Access Compliance Report

Public Rights-of-Way

Intersection ID: 13254	Main Street: S_MINT_ST	Cross Street: WESTWOOD_AV	Location: SE
ADA ID: 6305A997F00A	Ramp Type: PerpDiag	Initial Pass/Fail: Pass	Overall Compliance: No
Severity Score: 0.25			
Codes/Mitigation Info/Possible Solution		Field Measurements/Component Compliance

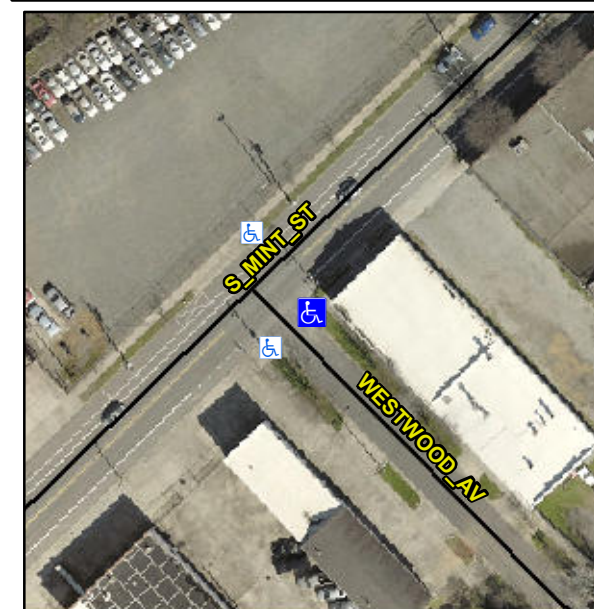
Not Found, R304.5.3, R304.2.2-Perp, R304.3.2-Para, R305.2

Compliance	Description	Data	Compliance	Description	Data
N/A	Ramp Length (in)	78.0	Yes	Ramp Slope (%)	5.9
Yes	Ramp Width (in)	48.0	No	Ramp XSlope (%)	2.6
N/A	Flare Type LT	Sloped	N/A	Flare Type RT	N/A
N/A	Flare Slope LT (%)	3.1	N/A	Flare Slope RT (%)	5.1
N/A	Flare Traversable LT?	No	N/A	Flare Traversable RT?	No
Yes	Landing Length (in)	59.0	Yes	DWS Provided?	Yes
Yes	Landing Width (in)	48.0	Yes	DWS Contrast?	Yes
No	Landing Slope (%)	3.0	Yes	DWS Length (in)	24.0
Yes	Landing X Slope (%)	0.5	Yes	DWS Full Width?	Yes
N/A	Landing Curb? (Y/N)	No	No	DWS Offset (in)	7.0
N/A	Shared Landing?	No			
Yes	Gutter Ponding?	No	Yes	Gutter Slope (%)	3.9
Yes	Gutter Lip Ht (in)	0.0	Yes	Gutter X Slope (%)	0.4
N/A	Painted X Walk1?	No	N/A	Painted X Walk2?	No
	X Walk 1 Direction	To NW		X Walk 2 Direction	To SW
N/A	X Walk 1 Width (in)	N/A	N/A	X Walk 2 Width (in)	N/A
	X Walk 1 Slope (%)	3.8		X Walk 2 Slope (%)	1.3
	X Walk 1 X Slope (%)	1.4		X Walk 2 X Slope (%)	0.7

N/A	Ramp inside XWalk1?	N/A	N/A	Ramp inside XWalk2?	N/A
	Road Slope (%)	0.9	N/A	Clear Space?	Yes
	Road X Slope (%)	3.9	N/A	Clear Space to XWalk (in)	N/A
Yes	Any Obstructions?	No	Yes	Storm Grate/Utility Hazard?	No
	Obstruction Type			Storm Grate/Utility Type	
		N/A			N/A
			Yes	Surface Condition? (G/P)	Good

Remove & Replace Curb Ramp With Two New Directional Ramps or Equivalent.
